US DEPARTMENT OF ENERGY
HANFORD WASTE VITRIFICATION PLANT

DESIGN CHANGE NOTICE

DCN – 0197	REV 0	PAGE 1 OF 31
DCN TITLE DELETION OF RWX PUMP HOUSE		DATE INITIATED 7/22/94 PACKAGE NO. A160

THIS DCN CONTAINS A PORTION OF THE WORK DESCRIBED IN CR-HWVP-1111, REV 1 AND COVERS THE FOLLOWING FOUR GENERAL ITEMS:

PROJECT TITLE: HANFORD WASTE VITRIFICATION PLANT
PROJECT: B-595
FLUOR CONTRACT NO.: 8457
CWBS NO.: A160
SCALE: NONE
BUILDING NO.: 23
INDEX NO.:
DRAWING NUMBER: H-2-126145
SHEET 5 OF REV. 0
DISTRIBUTION CODE: 504

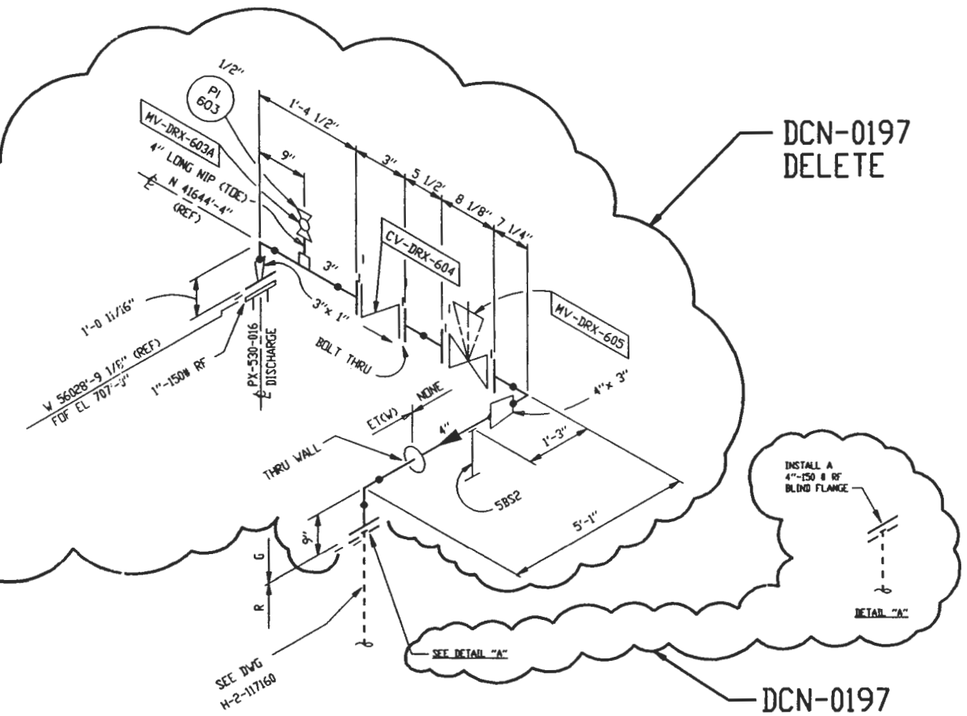
DCN-0197
DELETE

DELETED PX-530-016
AND RELATED PIPING. ADDED
A 4" BLIND FLANGE AS SHOWN.
